Appendix 13.8

CORRESPONDENCE WITH CDC AND LUC

From:	
To:	@quod.com
Subject:	RE: Baynards Green, Oxfordshire - LVIA Assessment
Date:	09 February 2024 10:37:15
Attachments:	image018.png image020.png image021.png image022.png image023.png image023.png image023.png image031.png image031.png image033.png image034.png image034.png image34.7313.png

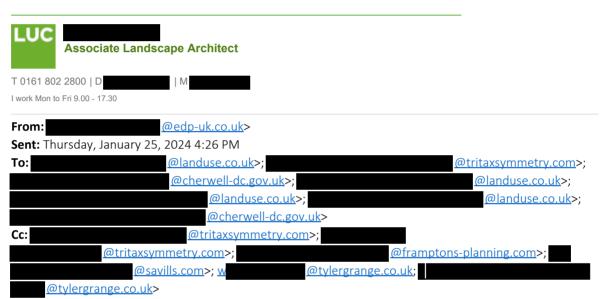
We have had the opportunity to undertake a desk based review of the EDP viewpoints/wirelines and wish to make the following early observations prior to our site visit:

- In all wireline views please add a solid fill to the built form, so we can understand what will be seen in front or behind within the photograph;
- In all wirelines, please can you ensure that the cumulative sites are included and clearly labelled;

- In all wirelines, please can you clearly describe the differences between parts of the proposed development, as it is not clear what you are viewing;

- EDP VP1 please relocate your viewpoint further to the south-west along the footpath, as the visibility of the proposed development is likely to be far greater;

- EDP VP4 please consider taking this viewpoint from the PROW to the west, to avoid screening by the foreground road hedge;
- EDP VP11 please relocate this viewpoint to Tyler Grange Viewpoint 10, which offers a more open aspect along the bridleway and which would be more representative of views experienced;

- EDP VP2 it would be of use to undertake a wireline from this viewpoint, to understand how much of the proposed development would be seen over the existing woodland;

- If you are not already considering additional Tyler Grange Viewpoints, we would suggest considering viewpoints 3, 9 and 12 as supplementary viewpoints;

- We would recommend an additional viewpoint from the bridleway adjacent to Park Farm to the north of the site, to better appreciate the visual effects upon the property and recreational route (in proximity to 455502, 230350, subject to further site work);

- It would be helpful to have wirelines from all viewpoints, including those recommended above; and
- Do you have any views from Tusmore Park which substantiates the reason for not including this as a receptor.
